Access Compliance Report

Public Rights-of-Way

(Curb Ramps)

Intersection ID: 9081	Main Street: BEATTIES_FORD_RD	Cross Street: DUNDEEN_ST	Location: NW
ADA ID: 7D41B06BAA5B	Ramp Type: Perp	Initial Pass/Fail: Fail	Overall Compliance: No
Severity Score: 22.5			
Codes/Mitigation Info/Possible Solution		Field Measurements/Component Compliance

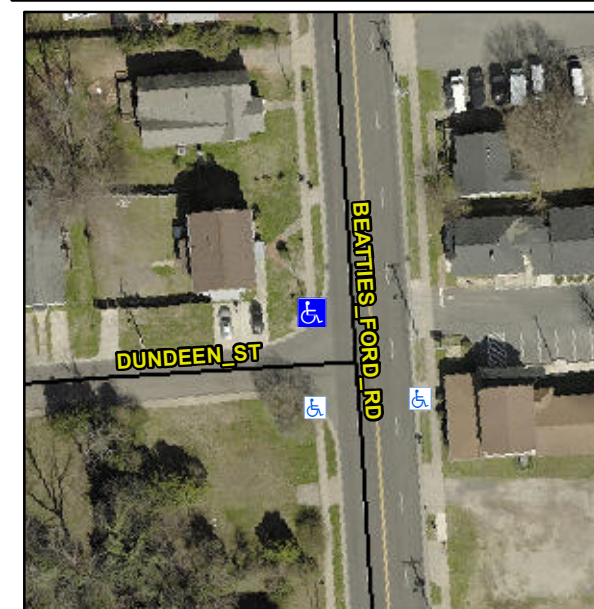
Not Found, R304.5.1, R304.2.2, R304.5.3

Compliance	Description	Data	Compliance	Description	Data
N/A	Ramp Length (in)	58.5	No	Ramp Slope (%)	8.4
No	Ramp Width (in)	41.0	No	Ramp XSlope (%)	3.6
N/A	Flare Type LT	N/A	N/A	Flare Type RT	N/A
N/A	Flare Slope LT (%)	N/A	N/A	Flare Slope RT (%)	N/A
N/A	Flare Traversable LT?	N/A	N/A	Flare Traversable RT?	N/A
N/A	Landing Length (in)	N/A	N/A	DWS Provided?	N/A
N/A	Landing Width (in)	N/A	N/A	DWS Contrast?	N/A
N/A	Landing Slope (%)	N/A	N/A	DWS Length (in)	N/A
N/A	Landing X Slope (%)	N/A	N/A	DWS Full Width?	N/A
N/A	Landing Curb? (Y/N)	N/A	N/A	DWS Offset (in)	N/A
N/A	Shared Landing?	N/A			
N/A	Gutter Ponding?	N/A	N/A	Gutter Slope (%)	N/A
N/A	Gutter Lip Ht (in)	N/A	N/A	Gutter X Slope (%)	N/A
N/A	Painted X Walk1?	No	N/A	Painted X Walk2?	N/A
	X Walk 1 Direction	To S		X Walk 2 Direction	N/A
N/A	X Walk 1 Width (in)	N/A	N/A	X Walk 2 Width (in)	N/A
	X Walk 1 Slope (%)	2.3		X Walk 2 Slope (%)	N/A
	X Walk 1 X Slope (%)	4.0		X Walk 2 X Slope (%)	N/A

Remove & Replace Entire Ramp.
